Interoffice
Communication

Subject: Tank Farm Vent System Evaluation

Figure 1 - Pressure/Flow Profile

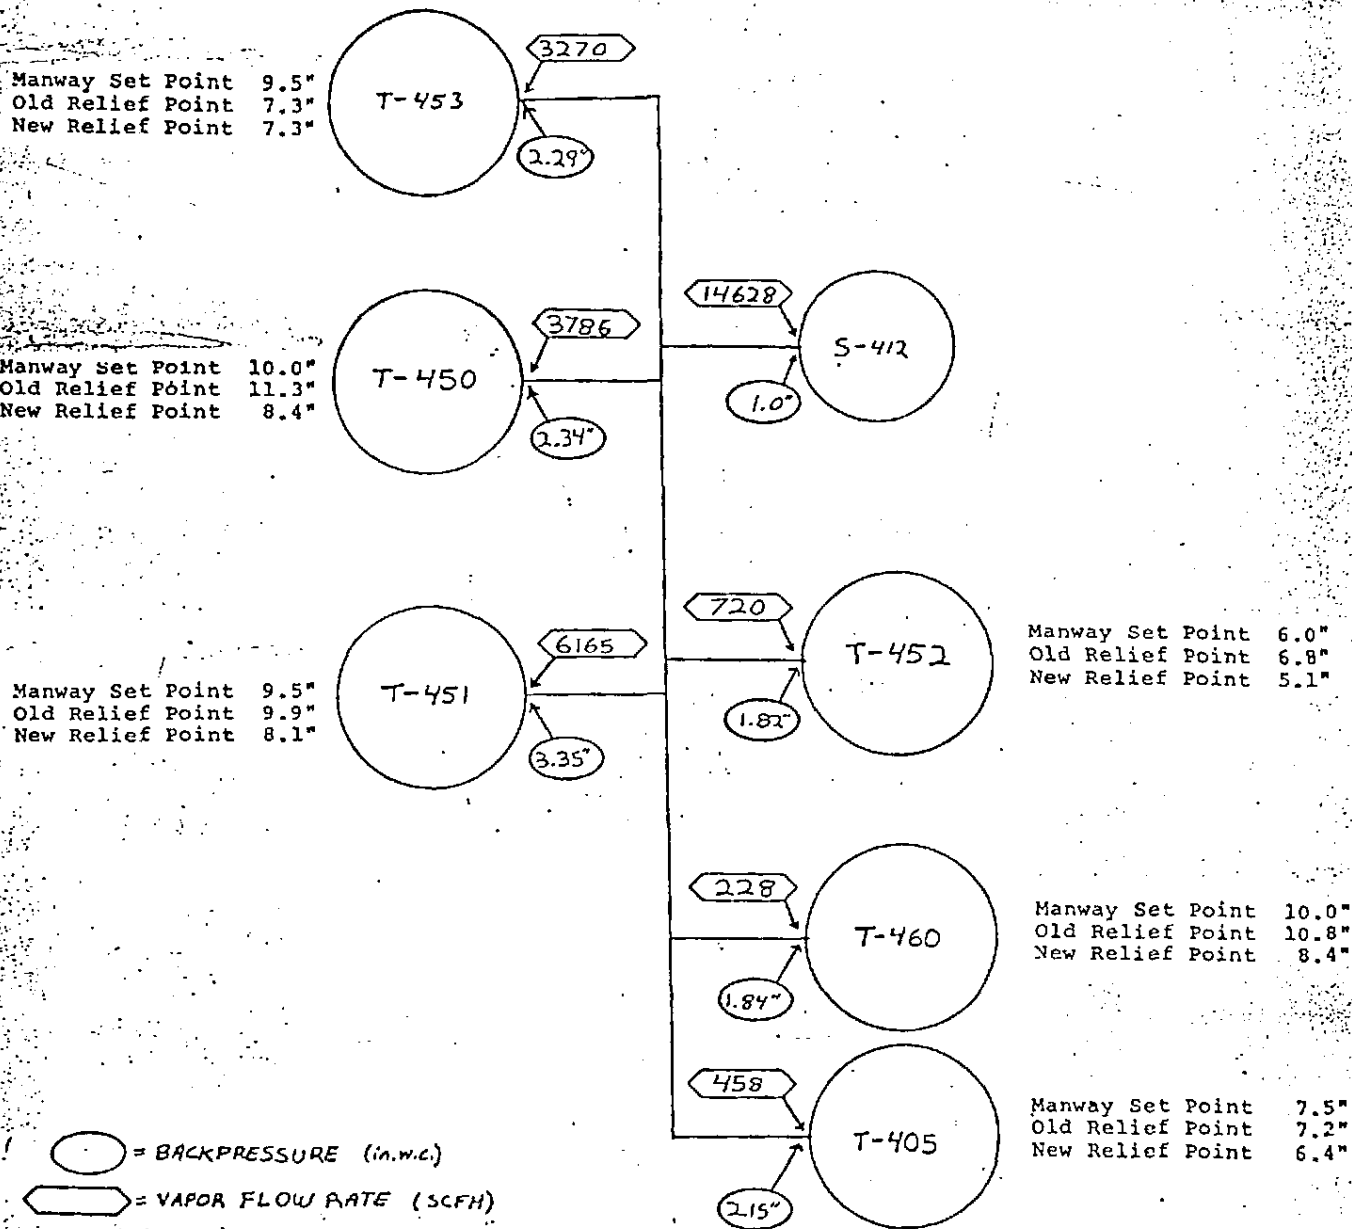
The pressure profile (Figure 1 and Table 4) shows considerable backpressure at the pressure-vacuum vents. Since the PV-vents are designed to relieve against atmospheric

pressure (0 psig), the backpressure prevents relief at the normal set point. For example, on T-451, the current PV-vent setpoint is 6.5" W.C. With the indicated backpressure of 3.4" W.C., the setpoint becomes 9.9" W.C., 0.9" higher than the blowoff manway setpoint, and 0.1" less than the roof design pressure. T-451 shows the most staining, supporting the fact that excessive backpressure is present at the PV-vents.

- What about T-453 blowoff manway?*
- 1) Adjust the pressure-vacuum vent setpoints to compensate for backpressure.
These new setpoints, shown in Table 1, will allow the PV-vent to open below the emergency vent setpoint, with at least a 15 % margin before the manway will relieve.
 - 2) Inspect the manway and PV-vent seals for corrosion. The seals should be replaced if signs of deterioration are present.

MY INFORMATION SHOWS A CURRENT SETTING OF 5.5" W.C. FOR THE MANWAY ON T-453. THE ROOF DESIGN IS ^{10.0}~~7.5~~" W.C. (THE MANWAY) AND THE MANWAY SHOULD BE SET HIGHER IF IT IS STILL AT 5.5" W.C. THIS WAS OVERLOOKED IN MAKING THE RECOMMENDATIONS. THANKS FOR BRINGING IT TO MY ATTENTION.
